Nuclear Regulatory Authority

Partial Revision of the Application for approval to amend the Implementation Plan for Fukushima Daiichi Nuclear Power Station as Specified Nuclear Facility

TEPCO partially revise Application for approval to amend the Implementation Plan for Fukushima Daiichi Nuclear Power Station as Specified Nuclear Facility, which submitted on Nov. 14, 2022 (Application No. FDEC-R4-143) and partially revised on Feb. 14, 2023 (Application No. FDEC-R4-179), as per the attached document.

Regard to the changes in operation structure of the ALPS treated water dilution/discharge facility and selection of nuclides subject to measurement and assessment in order to confirm before discharging ALPS treated water into the sea, the concept on abnormal values in sea area monitoring based on 1F Technical Meeting are made to be changed. The following amendments are made to this change.

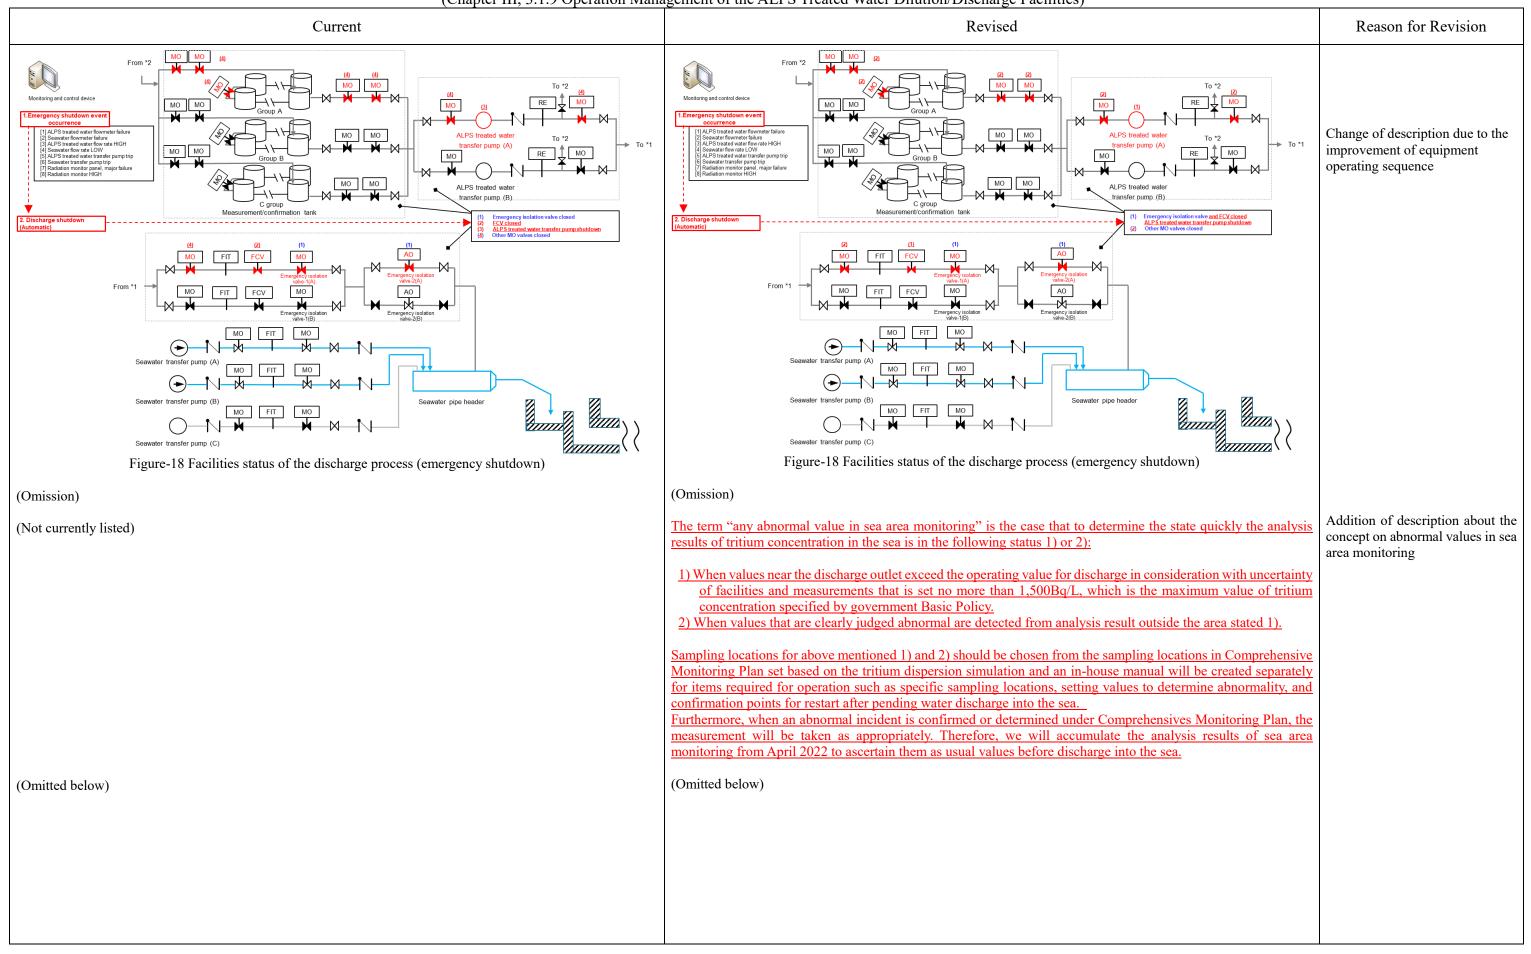
Revised Reason for Revision Current 1.9.3 Measures to abnormal occurrence, etc. 1.9.3 Measures to abnormal occurrence, etc. (Omission) (Omission) Manual shutdown in the event such Shutdown Manual shutdown in the event such as as an earthquake with seismic intensity of 5- or above or an an earthquake with seismic intensity of 5- or above or an issuance of tsunami advisory shall be carried out with Normal **Emergency** When shift supervisor considers it required, manual shutdown shall be carried out with following operations Operation Optimization of description issuance of tsunami advisory shall shutdown shutdown Normal Emergency system be carried out with following shutdown shutdown operations Shift Process shutdown Emergency shutdown team Process shutdown Emergency shutdown Shift team Measurement/confirmation tank Emergency shutdown water level low detected Monitorin Measurement/confirmation tank water Emergency shutdown event g/control level low detected device Monitoring [1] to [8] [9]* /control shutdown device Emergency Stop release nergency isolation valve-1,2 "close" activation shutdown Transfer Change of description due to the facility improvement of equipment ALPS treated water transfer pump Transfer "close" activation operating sequence facility MOV "close" activation Other MOV "close" activation Since "[9] Both series of emergency Other MOV "Close" action isolation valve panel communication Optimization of description abnormalities" is supposed that [1] ALPS treated water flowmeter failure Seawater flowmeter failure communication abnormality of control [2] Seawater flowmeter failure[3] ALPS treated water flow rate HIGH Since "[9] Both series of emergency isolation Emergency shutdown event panel for emergency isolation valve and valve panel communication abnormalities" is [4] Seawater flow rate LOW[5] ALPS treated water transfer pump trip operation of system is expected no [1] ALPS treated water flowmeter failure supposed that communication abnormality of [2] Seawater flowmeter failure

[3] ALPS treated water flow rate HIGH failure, we plan the same suspending control panel for emergency isolation valve and [6] Seawater transfer pump trip process as normal shutdown operation operation of system is expected no failure, we [7] Radiation monitor panel, major failure [4] Seawater flow rate LOW plan the same suspending process as normal [8] Radiation monitor HIGH [5] ALPS treated water transfer pump trip shutdown operation [6] Seawater transfer pump trip [9] Both series of emergency isolation [7] Radiation monitor panel, major failure valve panel communication [8] Radiation monitor HIGH [9] Both series of emergency isolation valve panel communication abnormalities Figure-17 Normal and emergency shutdown flows during the discharge process Figure-17 Normal and emergency shutdown flows during the discharge process

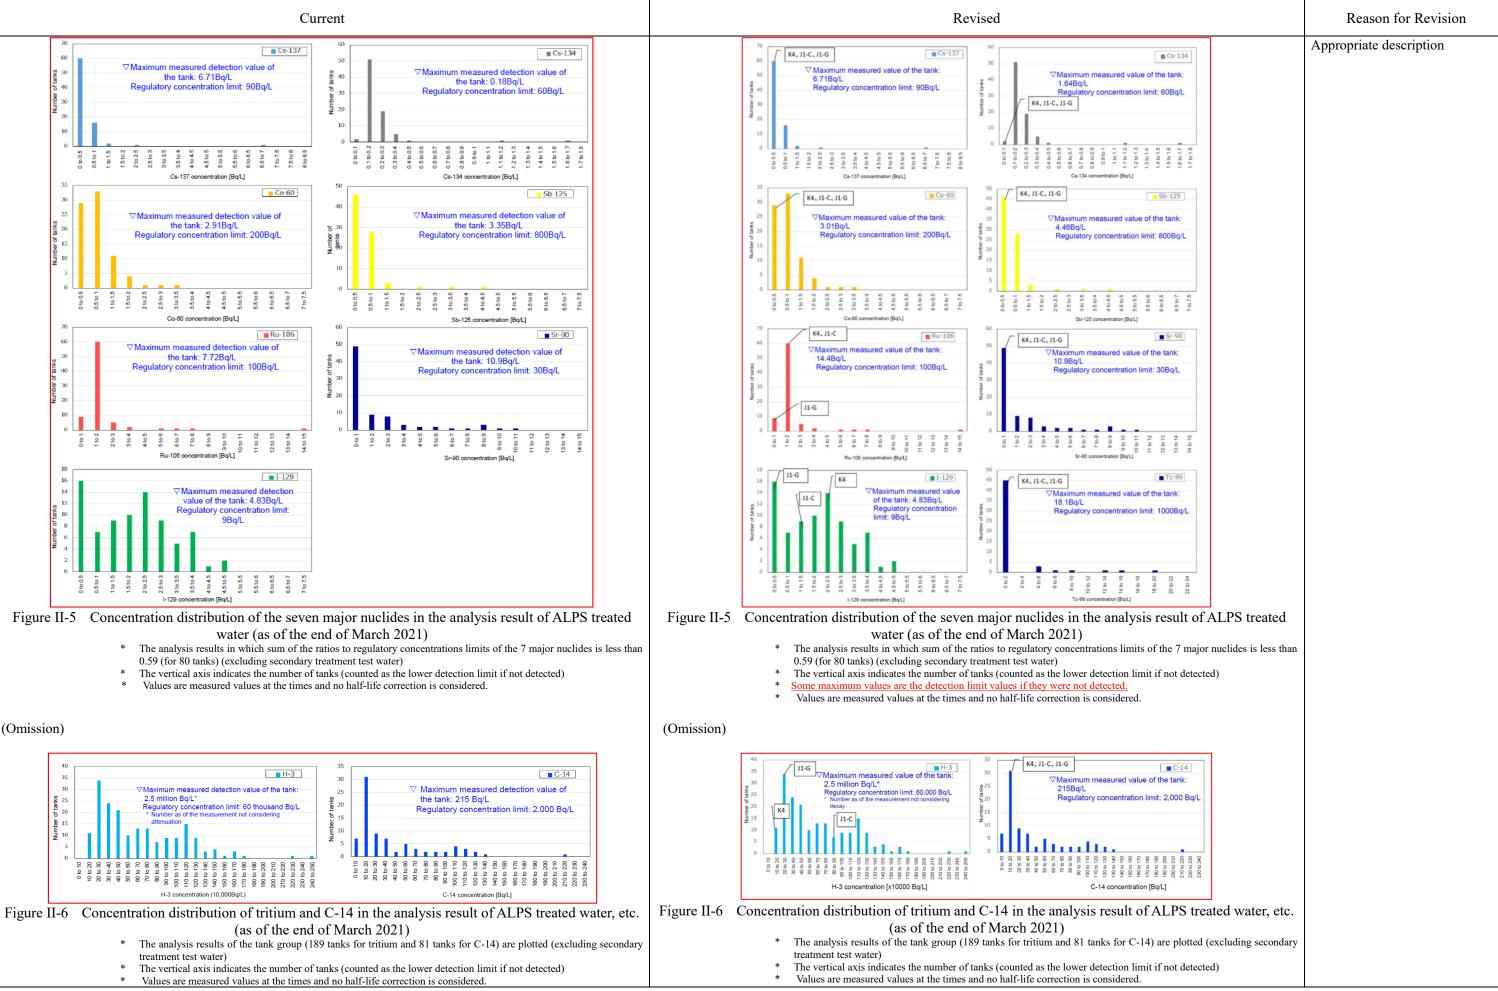
Current	Revised	Reason for Revision
II-5. Analysis of the radioactive materials in the stored ALPS treated water, etc.	II-5. Analysis of the radioactive materials in the stored ALPS treated water, etc.	
(Omission)	(Omission)	
In other words, when the transfer destination tank group (8 to 10 tanks connected at the time of water reception) becomes full, water of which ratios to regulatory concentrations limits of $\underline{63}$ nuclides other than tritium were estimated to be less than 1 using the following formula is judged as ALPS treated water and the other water as treated water to be purified, based on the measurement result of the sample (water) collected in the ALPS outlet (measured point (7)) during reception of water in the corresponding tanks group from ALPS. $C_{All} = C_{M7} + C_{C-14} + C_{55} < 1$ Where $C_{All} : \text{Sum of the ratios to regulatory concentrations limits of } \underline{63} \text{ nuclides other than tritium}$ $C_{M7} : \text{Sum of the ratios to regulatory concentrations limits calculated from the measurement results of the seven major nuclides}$ $C_{C-14} : \text{Ratio to the regulatory concentrations limit of } C-14 \text{ (conservatively set to the ratio to the regulatory concentrations limit of } 0.11 \text{ calculated from the maximum concentration}$ $(215\text{Bq/L}) \text{ measured in the past}$ $C_{55} : \text{Estimated value of the sum of the ratios to regulatory concentrations limits of the \underline{55} nuclides not included in the 7 nuclides among the \underline{62} nuclides (The estimated value based on the past measurement results is set to 0.3)$	In other words, when the transfer destination tank group (8 to 10 tanks connected at the time of water reception) becomes full, water of which ratios to regulatory concentrations limits of nuclides other than tritium were estimated to be less than 1 using the following formula is judged as ALPS treated water and the other water as treated water to be purified, based on the measurement result of the sample (water) collected in the ALPS outlet (measured point (7)) during reception of water in the corresponding tanks group from ALPS $C_{All} = C_{M7} + C_{C-14} + C_0 < 1$ Where $C_{All} : \text{Sum of the ratios to regulatory concentrations limits of nuclides other than tritium } C_{M7} : \text{Sum of the ratios to regulatory concentrations limits calculated from the measurement results of the seven major nuclides} $ $C_{C-14} : \text{Ratio to the regulatory concentrations limit of C-14 (conservatively set to the ratio to the regulatory concentrations limit of 0.11 calculated from the maximum concentration (215Bq/L) measured in the past)} $ $C_{Q} : \text{Estimated value of the sum of the ratios to regulatory concentrations limits of the nuclides not included in the 7 nuclides among the nuclides other than tritium (The estimated value based on the past measurement results is set to 0.3)} $	Appropriate description due to the selection of nuclides to be measured and assessed

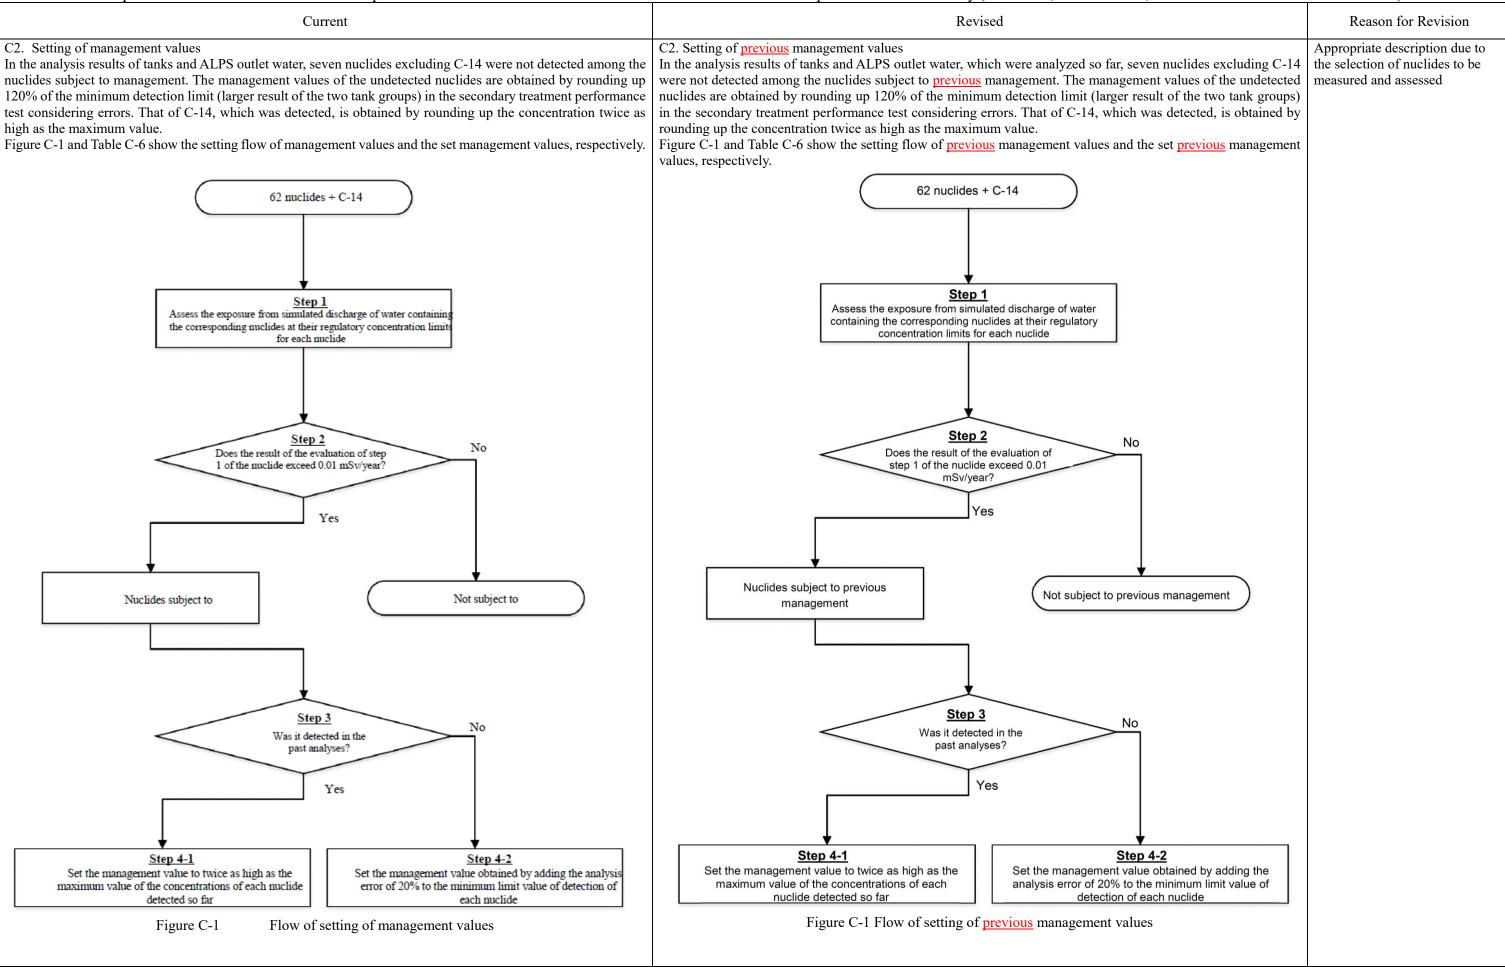
*Nuclid	es subject to man	agement are hatch	ed				*Nuclide	es subject to prev	<mark>rious</mark> management	are hatched				Appropriate description due to the selection of nuclides to be measured and assessed
